Access Compliance Report

Public Rights-of-Way

(Curb Ramps)

Intersection ID: N/A	Main Street: SOUTHGROVE_ST	Cross Street: WAVERLY_CENTER_DR	Location: SW
ADA ID: 3DAED0B6E116	Ramp Type: Perp	Initial Pass/Fail: Fail	Overall Compliance: No
Severity Score: 10			
Codes/Mitigation Info/Possible Solution		Field Measurements/Component Compliance

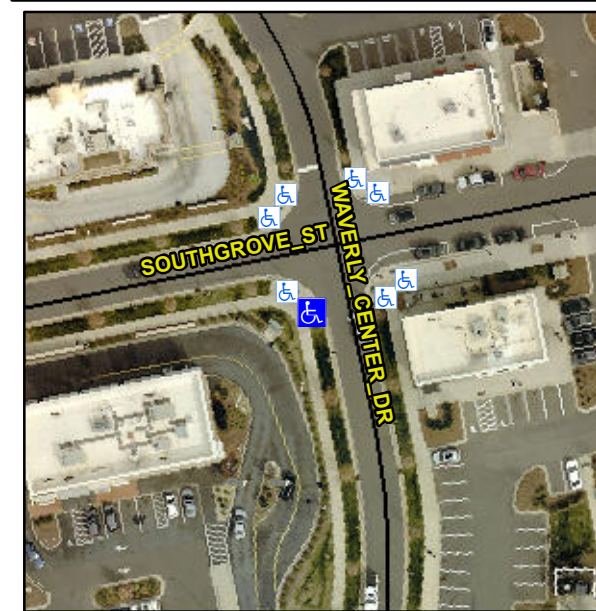
Not Found, R304.5.1, R304.5.3

Compliance	Description	Data	Compliance	Description	Data
N/A	Ramp Length (in)	96.0	Yes	Ramp Slope (%)	6.3
No	Ramp Width (in)	46.0	No	Ramp XSlope (%)	2.3
N/A	Flare Type LT	N/A	N/A	Flare Type RT	N/A
N/A	Flare Slope LT (%)	N/A	N/A	Flare Slope RT (%)	N/A
N/A	Flare Traversable LT?	N/A	N/A	Flare Traversable RT?	N/A
N/A	Landing Length (in)	N/A	N/A	DWS Provided?	N/A
N/A	Landing Width (in)	N/A	N/A	DWS Contrast?	N/A
N/A	Landing Slope (%)	N/A	N/A	DWS Length (in)	N/A
N/A	Landing X Slope (%)	N/A	N/A	DWS Full Width?	N/A
N/A	Landing Curb? (Y/N)	N/A	N/A	DWS Offset (in)	N/A
N/A	Shared Landing?	N/A			
N/A	Gutter Ponding?	N/A	N/A	Gutter Slope (%)	N/A
N/A	Gutter Lip Ht (in)	N/A	N/A	Gutter X Slope (%)	N/A
N/A	Painted X Walk1?	No	N/A	Painted X Walk2?	N/A
	X Walk 1 Direction	To E		X Walk 2 Direction	N/A
N/A	X Walk 1 Width (in)	N/A	N/A	X Walk 2 Width (in)	N/A
	X Walk 1 Slope (%)	1.3		X Walk 2 Slope (%)	N/A
	X Walk 1 X Slope (%)	0.7		X Walk 2 X Slope (%)	N/A

Remove & Replace Entire Ramp.
